Appendix 3-L

MMR Issues
Regarding Wind Farm

SUBJECT: Issues and Concerns Regarding Wind Farm Proposal; MMR Alternative

**REPORT OF ISSUES AND CONCERNS REGARDING THE PROSPECT OF A WIND ENERGY
“FARM” AT THE MASSACHUSETTS MILITARY RESERVATION**

Terrestrial Alternative
Massachusetts
Military Reserve
GE1.5 MW WTG Array

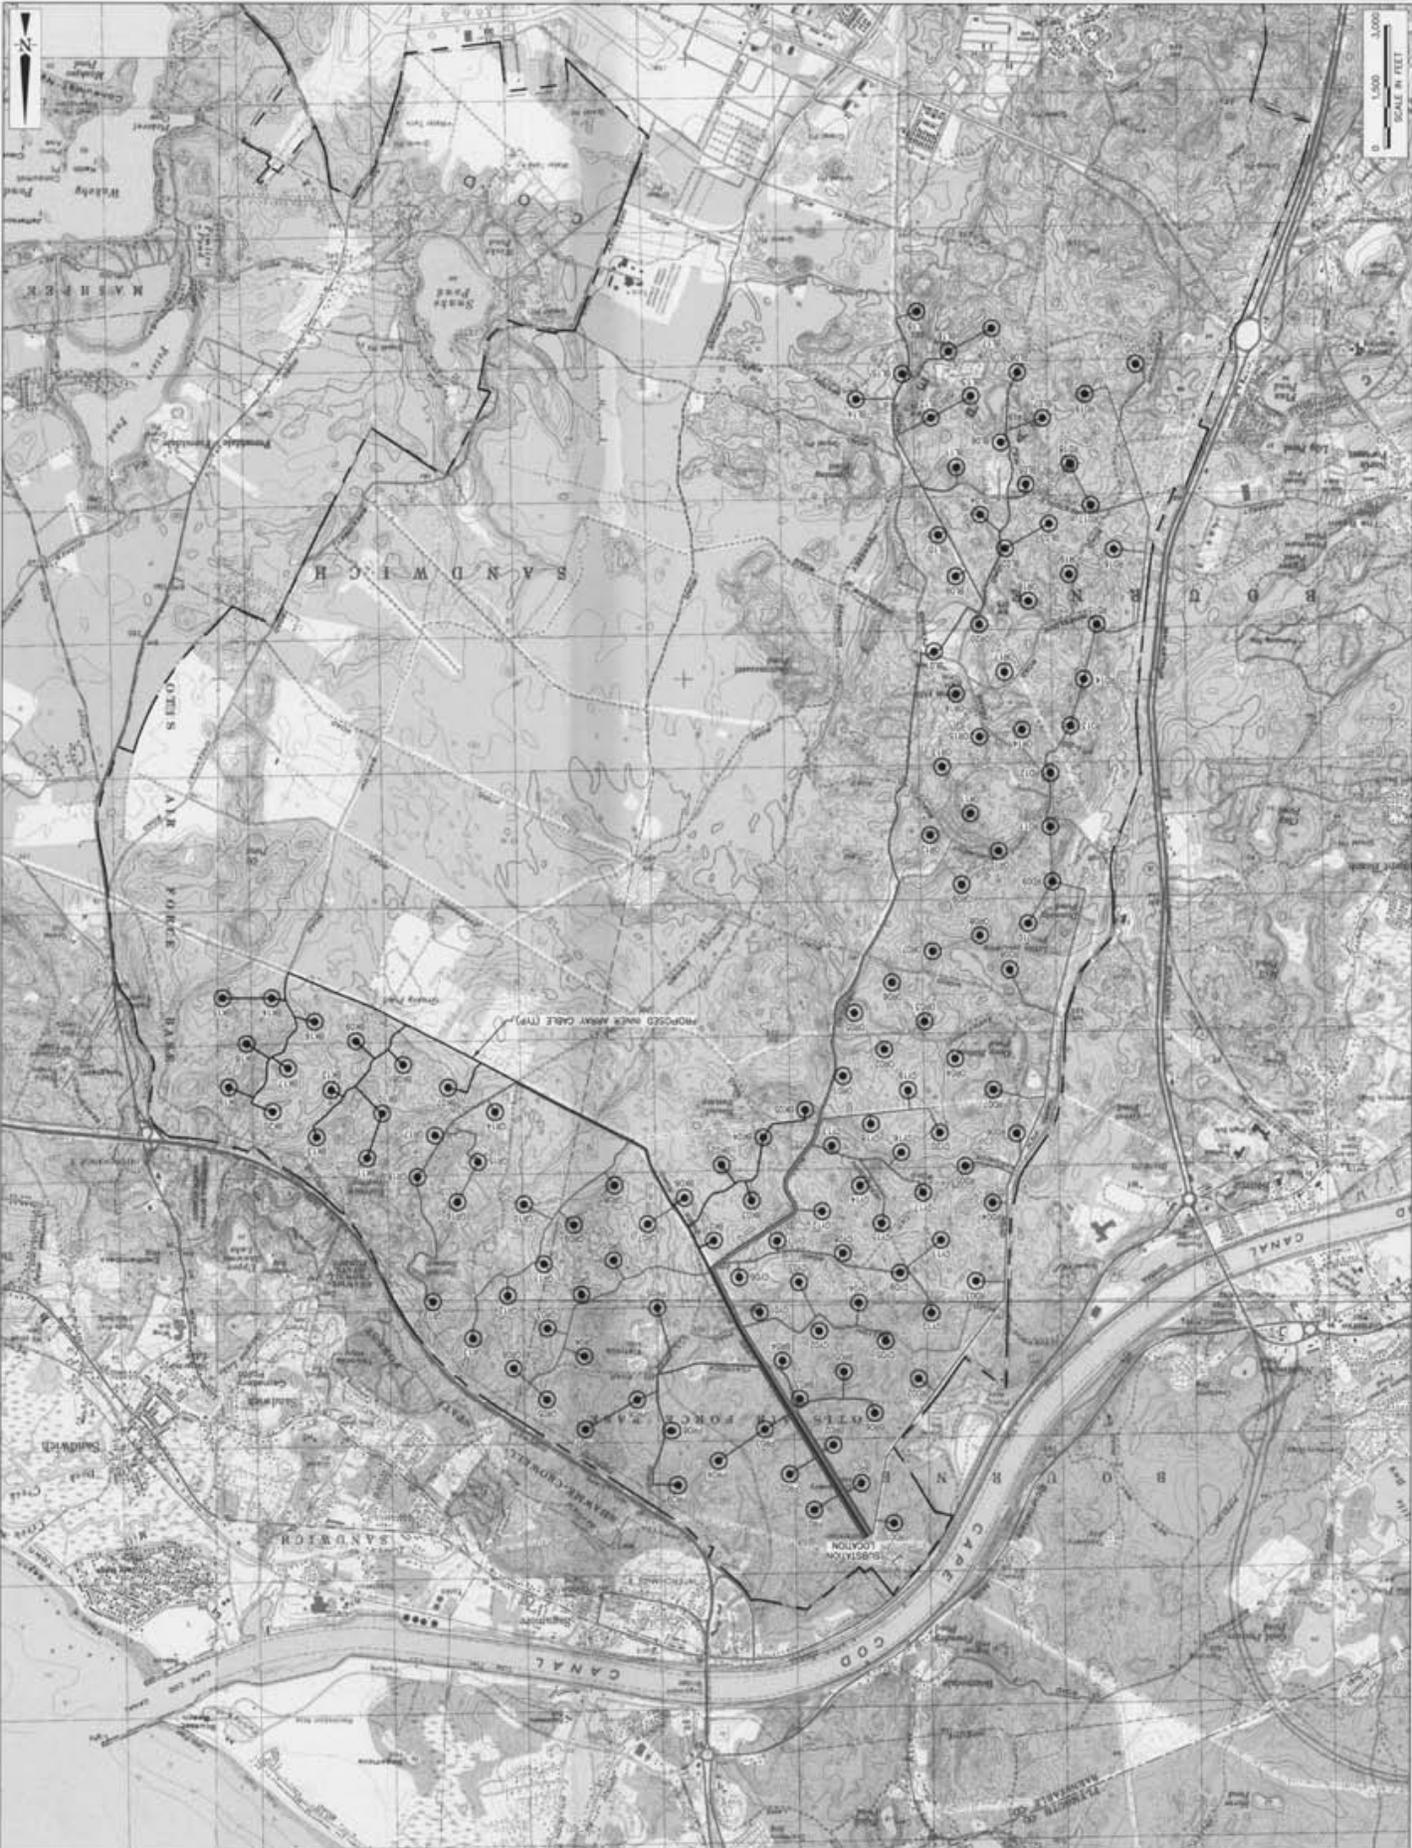
The Massachusetts National Guard has not taken, nor plans to take, a position regarding the original proposal by Cape Wind for construction of the wind energy facility in Nantucket Sound. The Massachusetts National Guard, however, wishes to state its legal, readiness, environmental, cultural and safety concerns and issues regarding the alternative of using the MMR for wind energy generation as shown in plans prepared by Cape Wind for 133 wind towers at the MMR and as shown on Plan MMR-1 dated December 2, 2003.

B. Aviation Concerns for Operation of F-15s (Report from the 102nd Fighter Wing, Massachusetts Air National Guard): The southern portion of the towers paralleling Rte 28 would be inside the “primary” final approach zone for the runway 14 TACAN approach. This could significantly impact F-15 operations in low ceiling conditions in a detrimental manner.

ROC above the highest obstacle in the “primary” zone is 250 feet. Add that to the average mean sea level where the towers would be (130 ft) and the height of the towers themselves (400 ft), and you have the required “new” Minimum Descent Altitude (MDA) for the approach – 780 ft msl. The current MDA is 580 ft, so there would be a 200-foot increase. Correspondingly the AGL weather ceiling required to fly the approach would be 700 feet (830 msl), up from the current 500 feet.

C. Aviation Concerns for small aircraft operated by Civil Air Patrol (Report from the 102nd Fighter Wing, MAANG): Light aircraft departing on Runway 32 could have problems clearing the towers on a “standard” climb straight ahead, requiring the minimum 152 feet per nautical mile climb-out rate. A missed approach on Runway 32 is not a factor, as the procedure requires a climbing turn to the southwest well away from the proposed tower locations.
